**WCAP-16996-P/ WCAP-16996-NP Volumes I, II, and III, Revision 0, “Realistic LOCA
[loss-off-coolant accident] Evaluation Methodology Applied to the Full Spectrum
of Break sizes (FULL SPECTRUM™ LOCA (FSLOCA) Methodology)”**

REQUEST FOR ADDITIONAL INFORMATION (RAI)

SECOND SET OF RAI QUESTIONS

RAI Questions 20 through 29

Figure: ANSI/ANS 5.1-1979 Tabular Data for Standard Decay Heat Power and Uncertainty for Thermal Fission of ^{235}U and ^{239}Pu and Fast Fission of ^{238}U for Irradiation of 10^{13} s

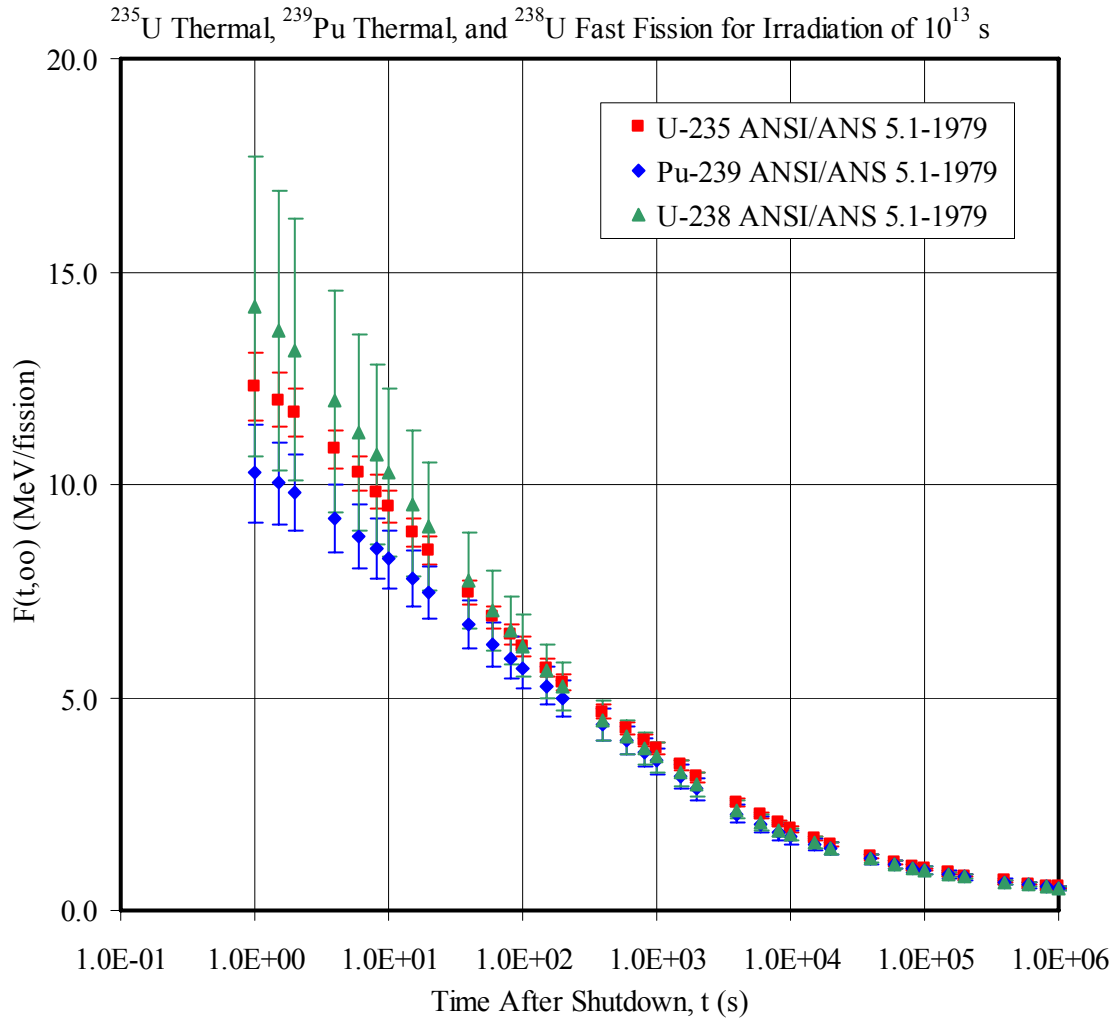
Please clarify and address, as needed, the following comments related to Section 9.7 and Figures 9-26 to 9-28.

- (1) It is believed that the units for decay heat on the Y-axis in each figure should be "MeV/fission" ($\text{MeV/fission} = [\text{MeV/s}]/[\text{fission/s}]$). Instead, the decay heat units appear as "MeV/sec/fission".

- (2) It appears that Figure 9-26 exhibits the decay heat function $F_i(t, T)$ for thermal fission of ^{235}U , Figure 9-27 plots $F_i(t, T)$ for the thermal fission of ^{239}Pu , and Figure 9-28 shows $F_i(t, T)$ for fast fission of ^{238}U for the infinite irradiation time ($T=10^{13}$ s) in all three plots. However, description for the plotted quantities is not provided in Section 9.7.
- (3) Only two data sets (curves) are seen in each of the plots. A third data set (curve) is not distinguishable and using symbols to indicate overlapping curves can be used if appropriate.

Please provide updated plots that represent the WCOBRA/TRAC-TF2 decay heat predictions for ^{235}U , ^{239}Pu , and ^{238}U for decay time from 0.1 s to 10^6 s. In each plot, please show the standard decay heat values $F_i(t, \infty)$ for ^{235}U , ^{239}Pu , and ^{238}U as tabulated in ANSI/ANS 5.1-1979, Tables 4, 5, and 6 representing each value by a symbol with a two-sided Y-error bar corresponding to $\pm 2\sigma$ uncertainty using the uncertainty data in the ANSI/ANS 5.1-1979 tables. The uncertainties in both ANSI/ANS 5.1-1979 and ANSI/ANS 5.1-2005 are currently represented in tabular form for the decay heat functions $f_i(t)$ and $F_i(t, \infty)$ and values for intermediate times are obtained by interpolation. The included figure presents the $F_i(t, \infty)$ ANSI/ANS 5.1-1979 Standard decay heat and uncertainty data for ^{235}U , ^{239}Pu , and ^{238}U . In each figure, plot a curve that shows the “nominal” WCOBRA/TRAC-TF2 decay heat prediction as a continuous function of time and then show two additional curves that represent uncertainties predicted by WCOBRA/TRAC-TF2 and representing the decay heat “upper bound” (nominal plus 2σ) and “lower bound” (nominal minus 2σ). Explain how the code predicts the uncertainties for $t < 1$ s as no standard data are provided.

Figure: ANSI/ANS 5.1-1979 Tabular Data for Standard Decay Heat Power Uncertainty for Thermal Fission of ^{235}U and ^{239}Pu and Fast Fission of ^{238}U for Irradiation of 10^{13} s

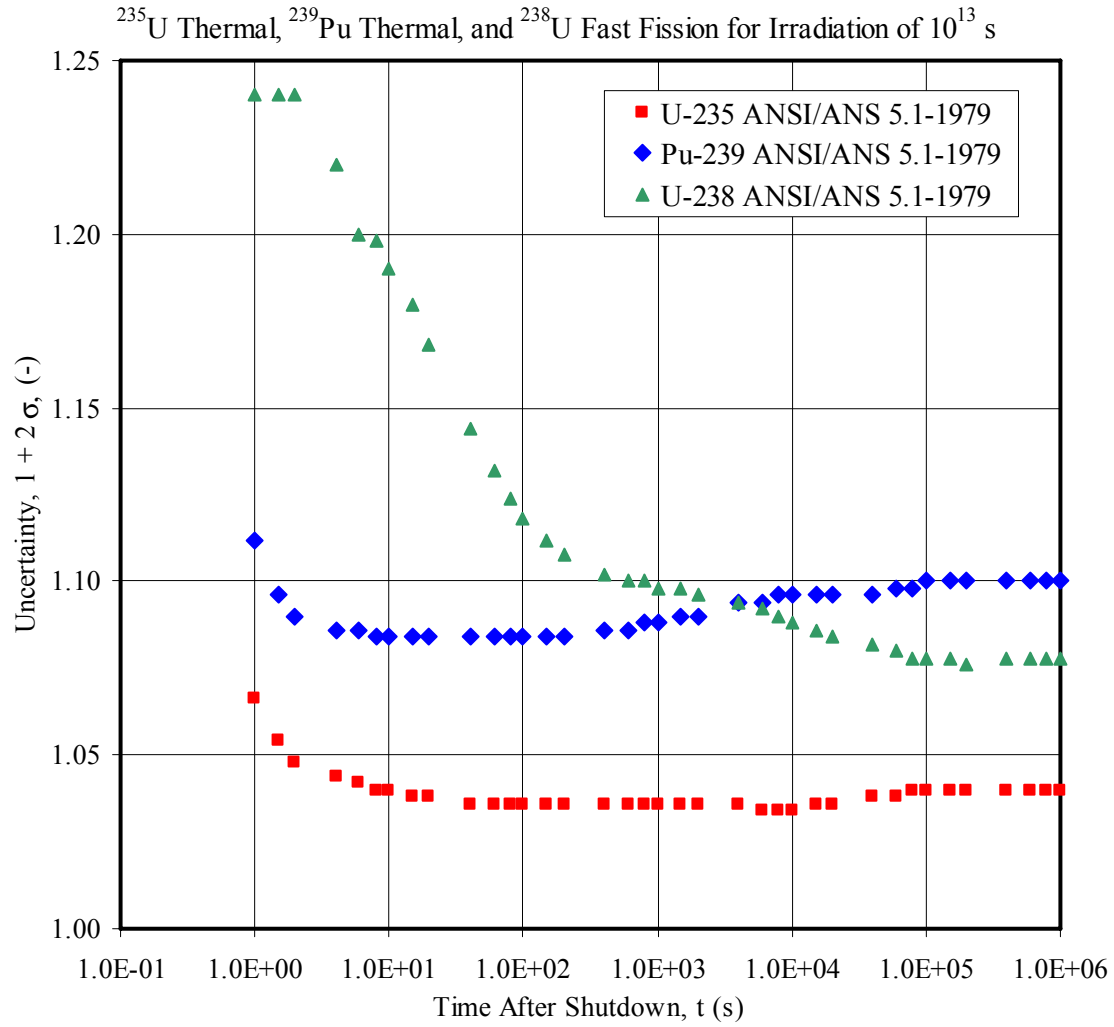
It is seen from Figures 9-23 to 9-25 that the plotted discrepancies exhibit most pronounced deviation during the first 100 s of cooling time. At the same time, approximately 25 percent of the residual decay energy is released in the first 10 s after the fission process ends and about 50 percent is released by 100 s after fission (see I. Gauld, "Validation of ORIGEN-S Decay Heat Predictions for LOCA Analysis," PHYSOR-2006, ANS Topical Meeting on Reactor Physics, Vancouver, BC, Canada, September 10-14, 2006).

Please explain how the quantity labeled "Deviation" and shown along the vertical Y-axis in Figures 9-23 to 9-25 for cooling time from 10^{-1} s to 10^9 s was computed and define the parameters "energy" and "decay heat" for which the results were plotted. Please provide updated plots that compare the WCOBRA/TRAC-TF2 uncertainty predictions for ^{235}U , ^{239}Pu , and ^{238}U for cooling time from 0.1 s to 10^6 s. In each plot, please show the uncertainty presented as $1+2\sigma$ and computed using the tabulated σ uncertainty percent values provided in ANSI/ANS 5.1-1979, Tables 4, 5, and 6. The included figure presents the ANSI/ANS 5.1-1979 Standard decay heat uncertainty data for ^{235}U , ^{239}Pu , and ^{238}U . In each figure, plot a curve that shows the WCOBRA/TRAC-TF2 decay heat uncertainty prediction as a continuous function of time. Explain how the code predicts the uncertainties for $t < 1$ s as no standard uncertainty data are provided. If the WCOBRA/TRAC-TF2 decay heat uncertainty model underestimates any of the ANSI/ANS 5.1-1979 Standard values, a correction factor needs to be implemented to ensure that the code calculates uncertainties that are not less than the standard values.
